**DEVELOPMENT APPLICATION DA2019/0347**

Proposed Alterations and additions to a dwelling house at 50 Waine Street, Freshwater NSW 2096 by Chiara Valente and Andrew Boyce.

Figure: Front setback encroachment, red shaded area shows standard setback.

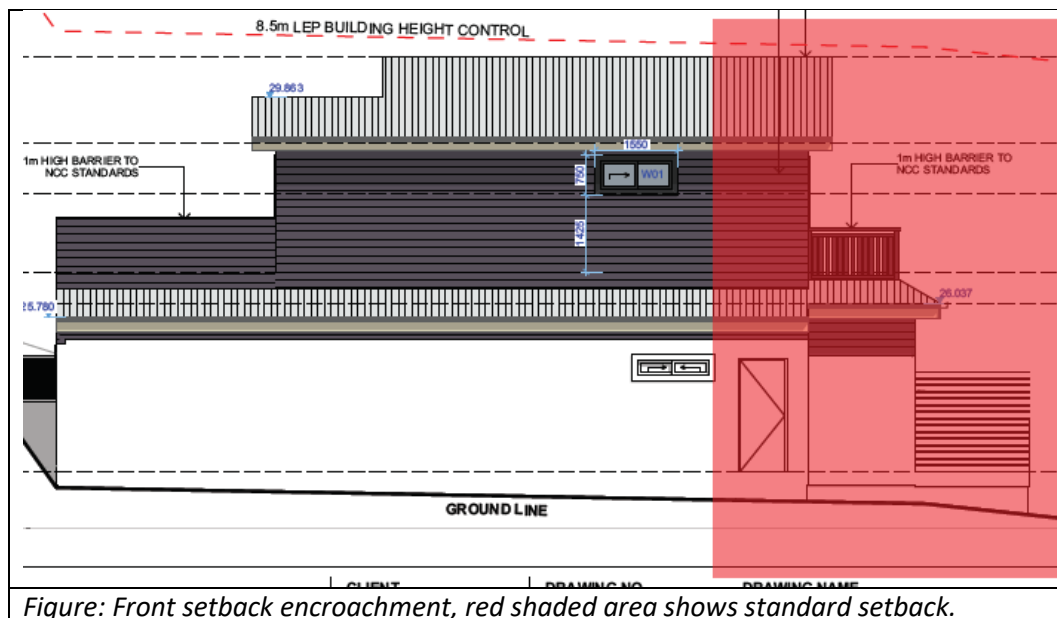
Existing house structure encroaches onto standard front setback, new construction exacerbates problems by building on this area. Existing side window already creates glare problems, proposed new window will be elevated and increase glare to intolerable levels. Proposed upstairs bathroom & window with associated noises and smells will be adjacent to neighbour's bedroom window.

- Front balcony and additional storey are constructed within front boundary setback area (DCP B7.2)
- Front balcony allows direct overlooking views into private rooms and areas of neighbouring property. (DCP D8.3)
- Side window allows direct vision into neighbouring windows. (DCP D8.3)
- Side window & balcony shine artificial lighting directly into bedroom windows. (DCP D12)
- Noise from front balcony adjacent to bedrooms (DCP D3.5)

## Attachment 2 – Rear balcony

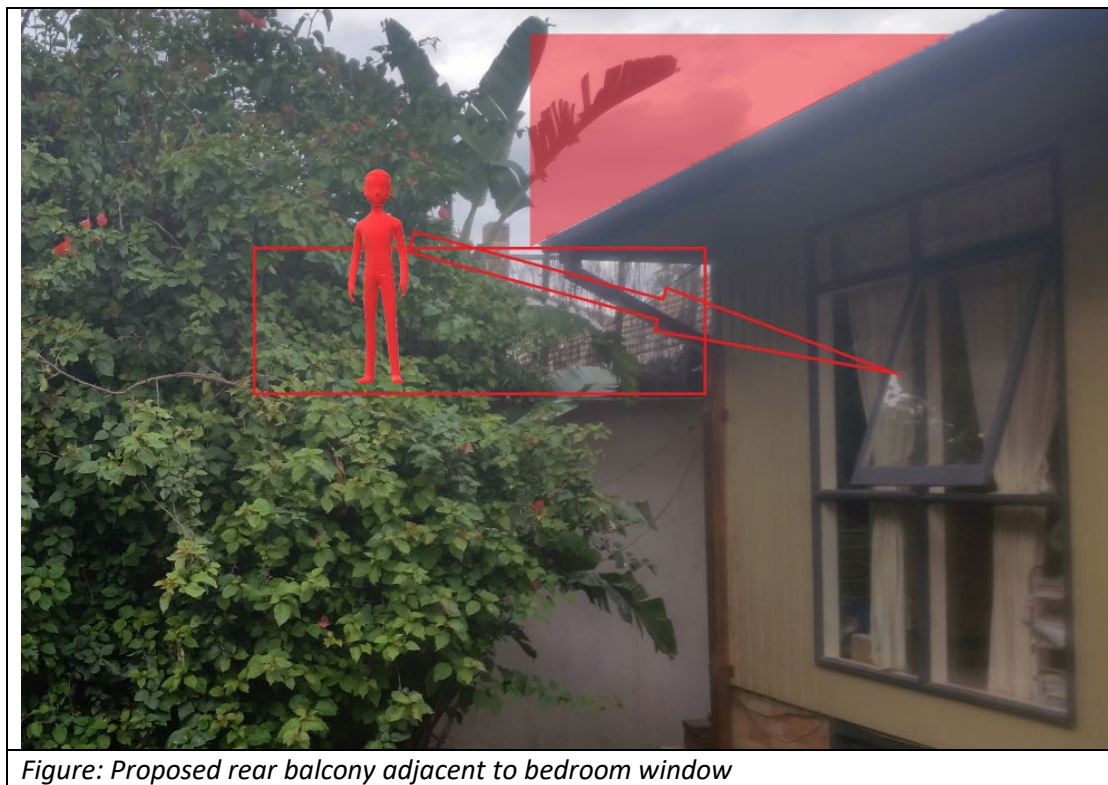
Proposed upstairs balcony is adjacent to and elevated to private areas of the neighbour's house. The balcony is oriented so that the widest part is towards side fence. This will facilitate & encourage direct view into bedrooms, bathrooms, and other private areas.

Existing house structure encroaches onto standard side setback, new construction exacerbates problems by building on this area.

- Rear balcony and additional storey are constructed within side boundary setback area (DCP B6)
- Rear balcony allows direct overlooking views into private rooms and areas of neighbouring property. (DCP D8.3)
- Balcony shines artificial lighting directly into bedroom windows. (DCP D12)
- Noise from balcony adjacent to bedrooms (DCP D3.5)

Figure: DA2019/0347 page 5, slope reversed.

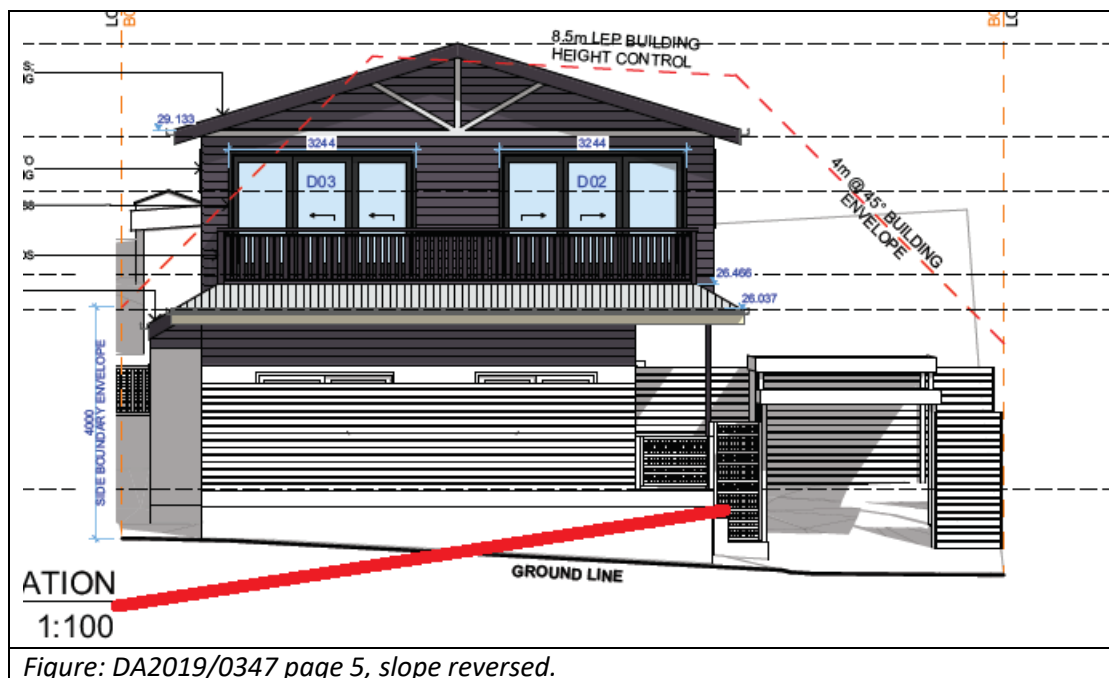
Stated western side setback of 0.58m does not agree with survey or actual siting. Setback to existing wall varies from 0.40m at front to 0.51m at rear.

East-West front view slope appears reversed.

*Figure: Gutter & drain over property boundary, eaves on or over boundary.*

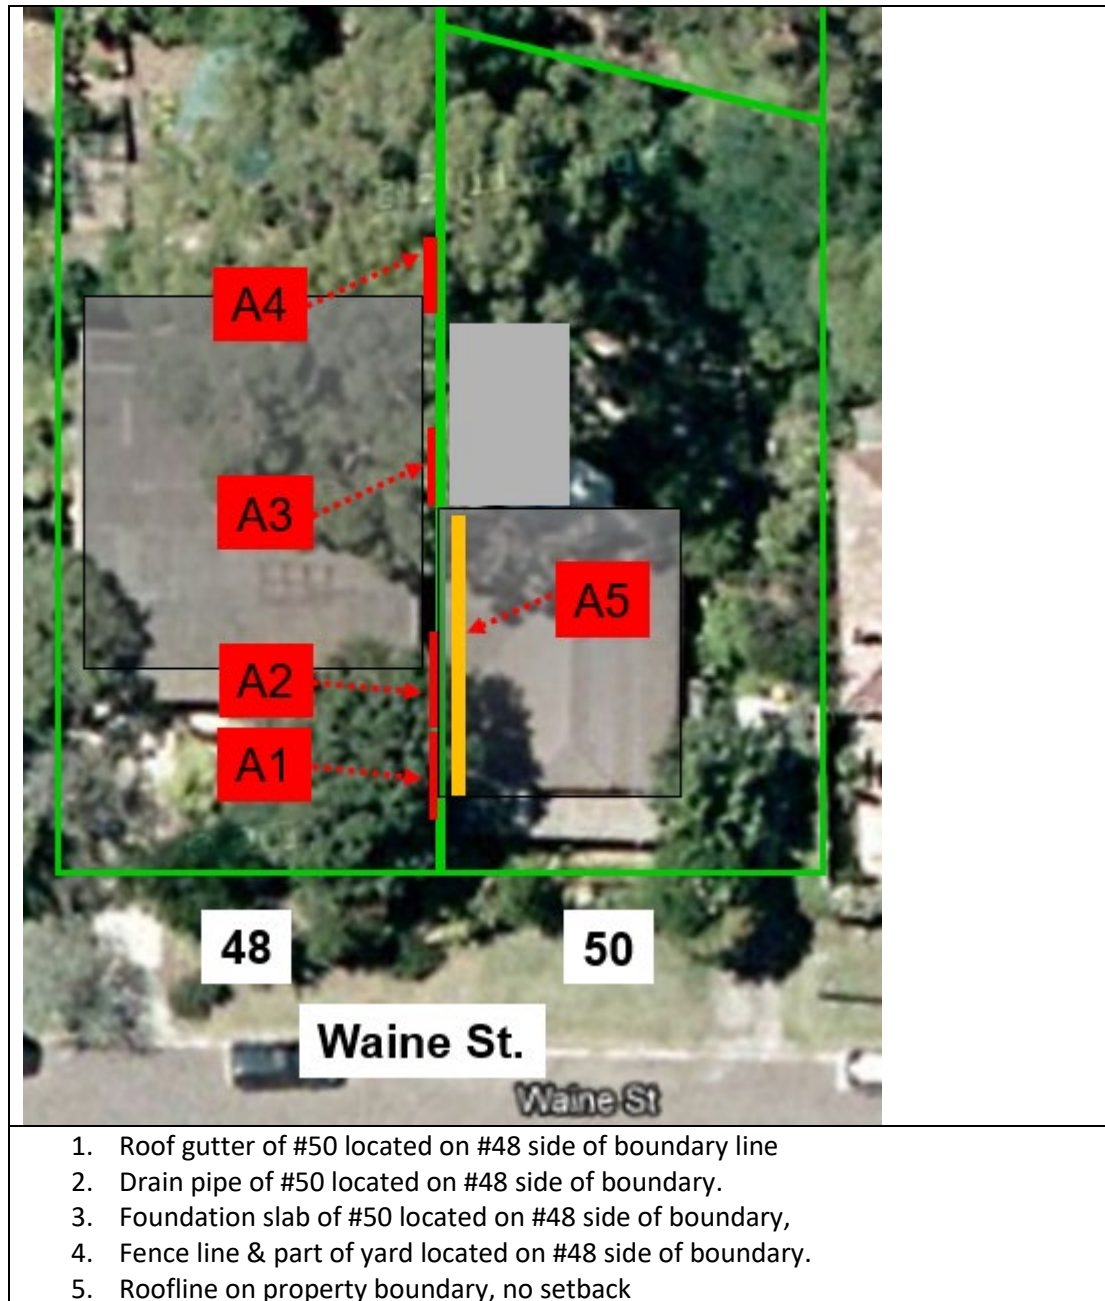
Note: Refer to 2011 surveyors report attached.

- Roof not cut back as per DA2015/0523

*Figure: Building bulk adjacent to fence line & bedroom windows.*

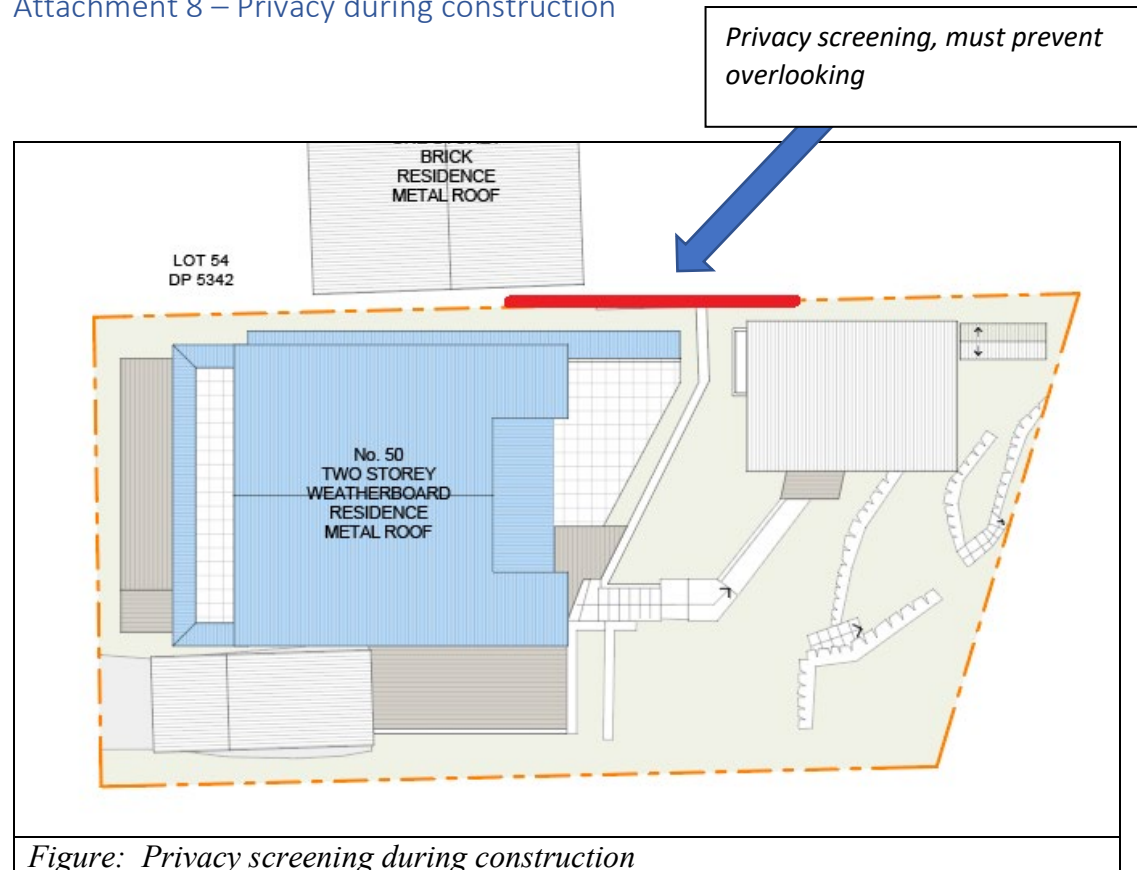
No attempt has been made to soften the appearance of the existing extension by #50. Cheap poorly finished materials have been used on the wall, including a top screening fence which shoddily constructed is leaning over the fence, and appears in danger of collapse.

All greenery in picture is located on #48. Adding onto the bulk by adding an additional story with gabled roof will make the situation even more intrusive and unsightly.
